## **Proposal for amendment to document ECE/TRANS/WP.29/2012/53 (a new Regulation on Child Restraints Systems)**

*Annex 2*, replace the first figure of the approval mark with the following:

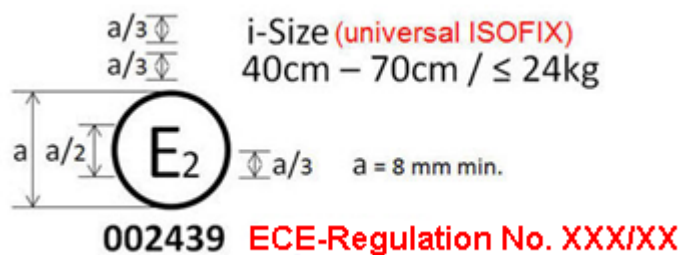
The Child Restraint System bearing the above approval mark is a device capable of being fitted in any i-size compatible vehicle **seating position** and of being used for the 40cm-70cm size range and mass limit of 24kg; it is approved in France (E2) under the number 00xxx. The approval number indicates that the approval was granted in accordance with the requirements of the Regulation concerning the approval of enhanced Child Restraint Systems used onboard of motor vehicles as amended by the 00 series of amendments. **In addition the name of the regulation has to be identified on the approval**

**mark followed by the series of amendment according to which the approval has been granted (“ECE-Regulation XXX/00” for the 00 series of amendments of regulation XXX).**

Annex 2, replace the second figure of the approval mark with the following:

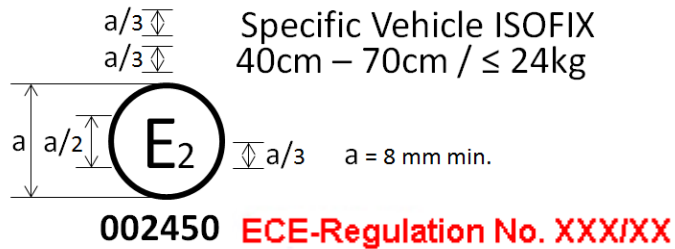
The Child Restraint System bearing the above approval mark is a device not capable of being fitted in every vehicle and of being used for the 40cm to 70cm size range and mass limit of 24kg; it is approved in France (E2) under the number 002450. The approval number indicates that the approval was granted in accordance with the requirements of the Regulation concerning the approval of Specific vehicle ISOFIX Child Restraint Systems used onboard of motor vehicles as amended by the 00 series of amendments. **In addition the name of the regulation has to be identified on the approval mark followed by the series of amendment according to which the approval has been granted (“ECE-Regulation No. XXX/00” for the 00 series of amendments of regulation XXX).**
